## ADDENDUM NO. 2

**TO: PLANS AND SPECIFICATIONS FOR STATE OF MISSOURI**

**State of Missouri St. Clair Readiness Center  
375 Commercial Avenue  
St. Clair Missouri 63077  
Project No. T2326-01**

**A351**

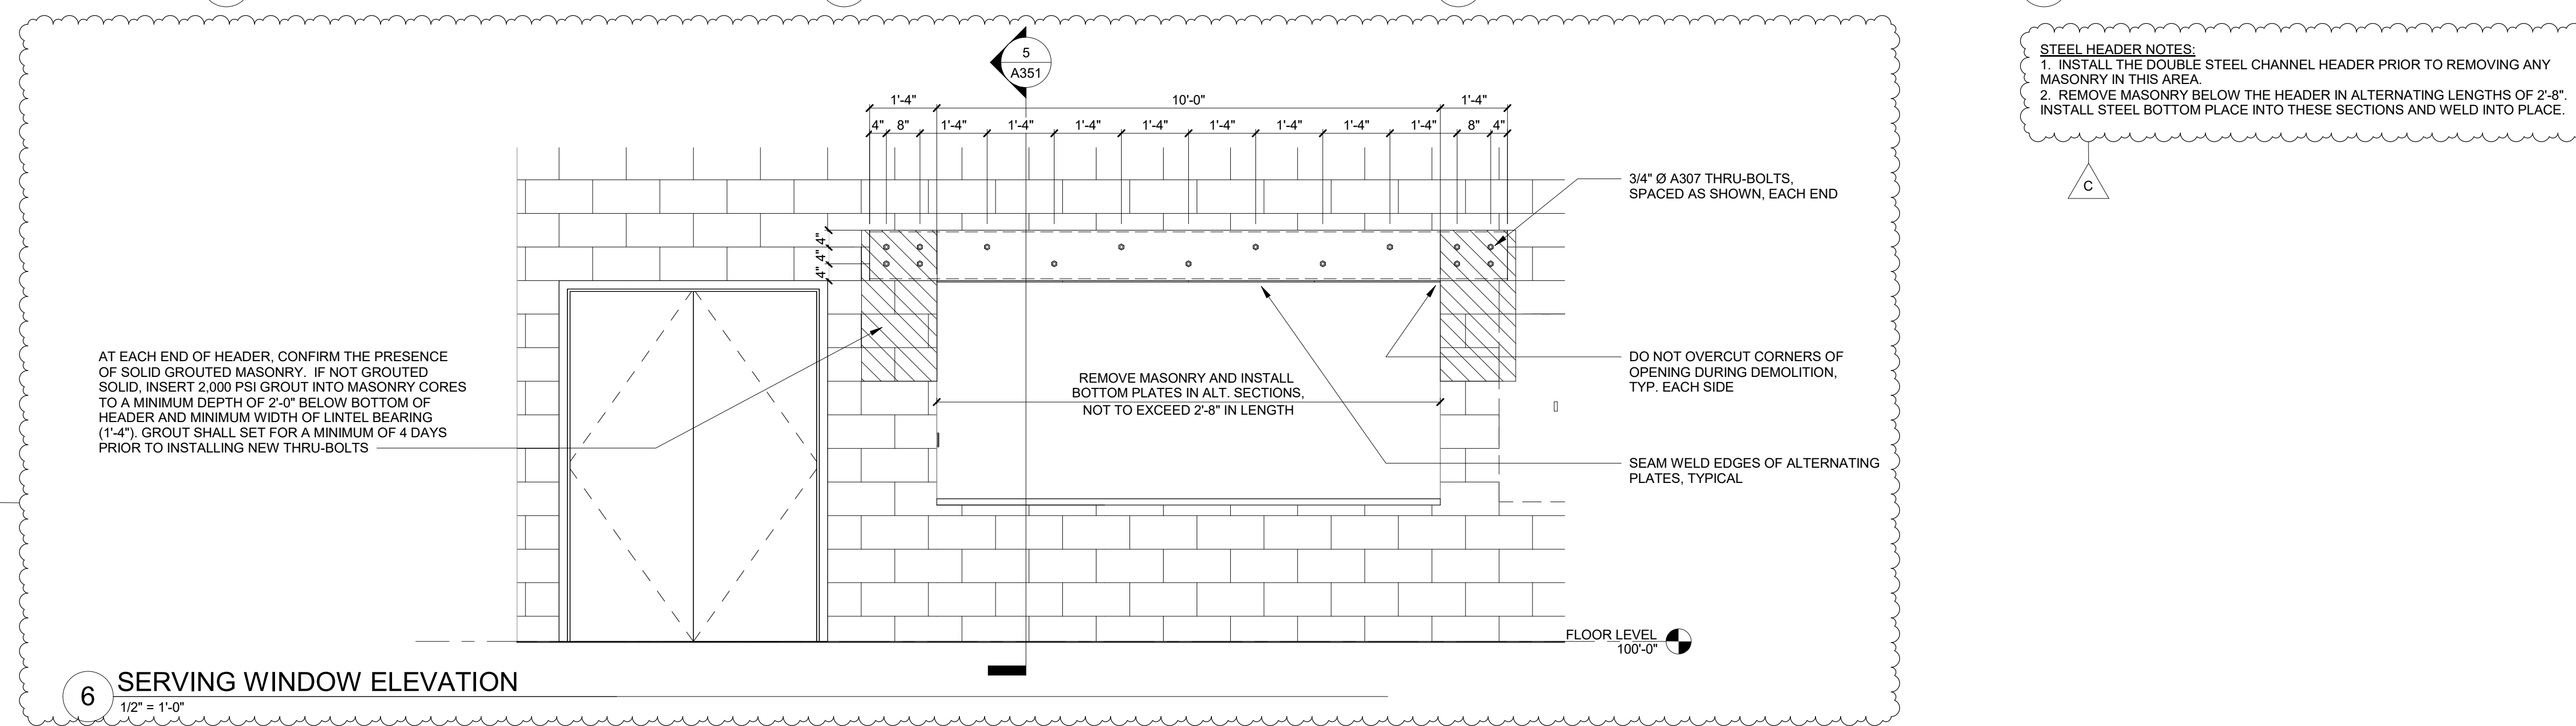
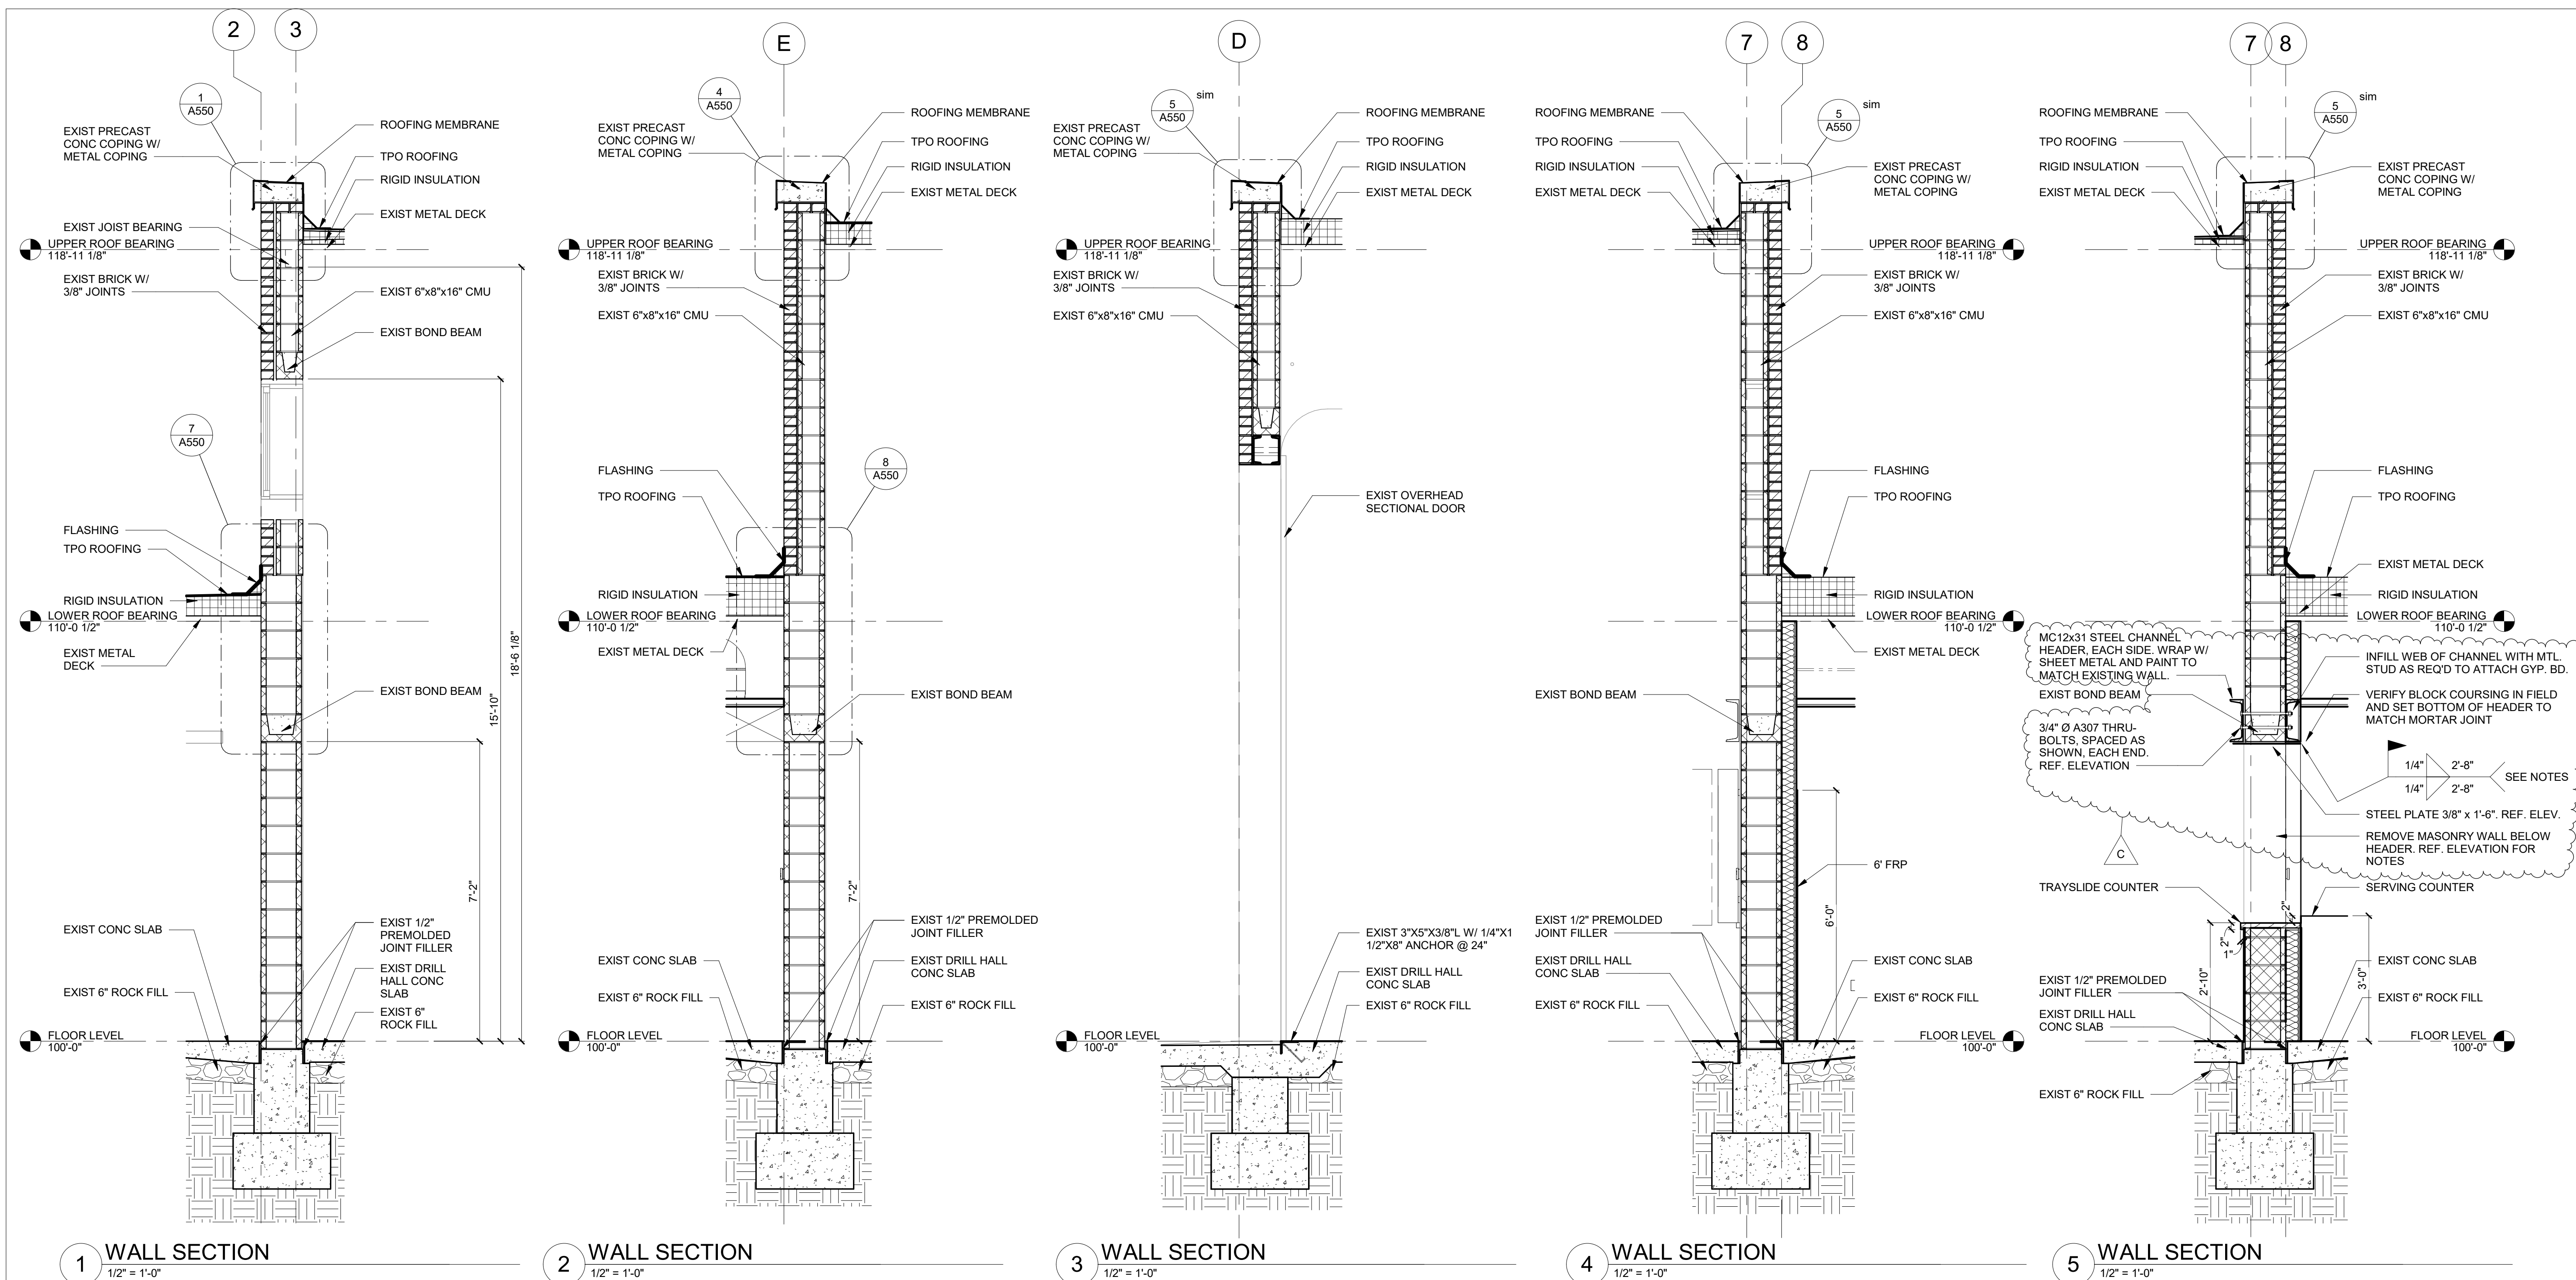
8. Drawing A201:
  - a. ADD Specifications note for the exterior ladder access signs
9. Drawing A351:
  - a. ADD Structural detail on wall section 5 for the counter opening in the kitchen.

- b. ADD Serving Window Elevation.
  - c. ADD Steel header note.
10. Drawing A700:
  - a. UPDATE Door Schedule.
11. Drawing A720:
  - a. UPDATE the partition schedule.

35. On 5 - A/351 when the wall is to be removed for the opening in the kitchen. Is there a structural drawing being issued in the Sept 5th addendum that gives us a direction on how we need to secure the load being opening?

**Q-FP-01**

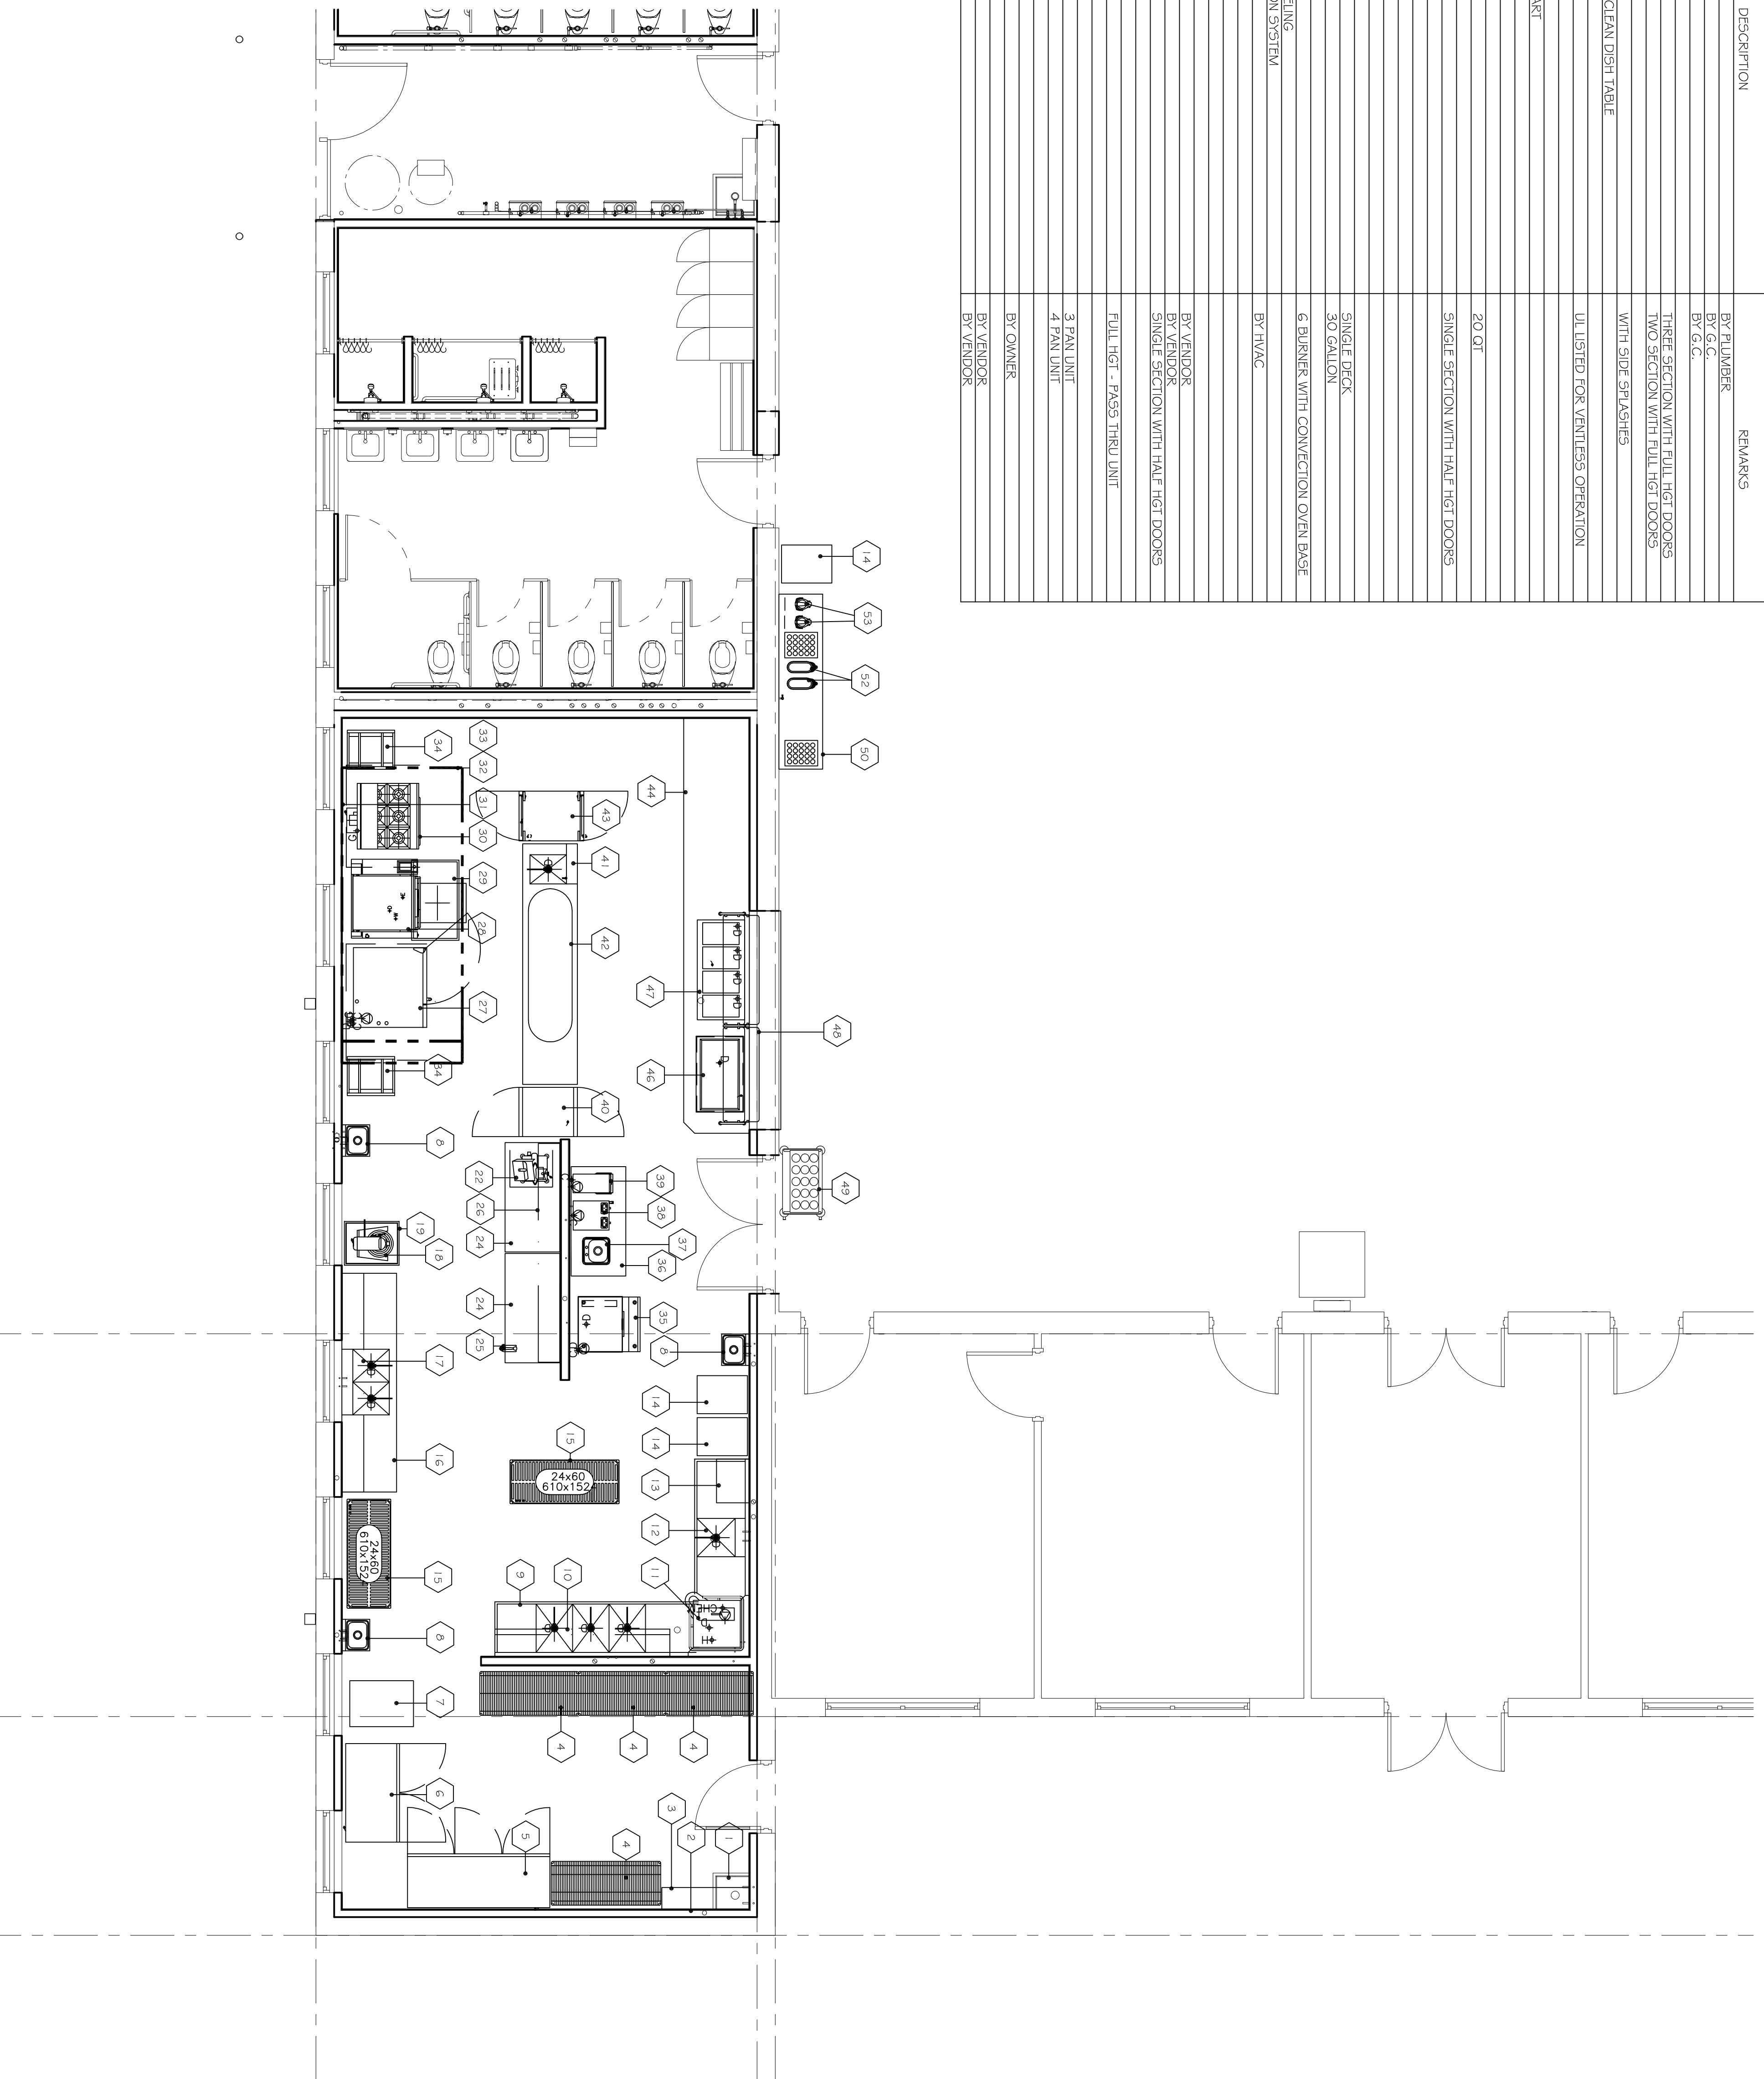
12. Drawing A800:
  - a. UPDATE Room Finish Schedule & Finish and Material Schedule
13. Drawing Q-FP-01:
  - a. CHANGE Racks quantity to be 2 Racks instead of 1.

20. Regarding Division 11400 foodservice equipment, will you please clarify the quantity to price for item 34 New Age racks. Specs and drawing schedule both list quantity 1 but drawing sheet Q-FP-01 shows quantity of 2?

30. Item #34 – Racks – Specification and equipment schedule lists quantity of (1), however, plan Q-FP-01 shows quantity of (2). Quoted quantity of (2) per plan Q-FP-01. Please verify quantity required.

- a. Item #34 RACKS: Provide quantity of TWO (2).
21. Is PSI going to be the on-site consultant for this project? This is the first that I have heard about this. We did do some preliminary work at this site in 2023.

- a. Item #34 RACKS: Provide quantity of TWO (2)
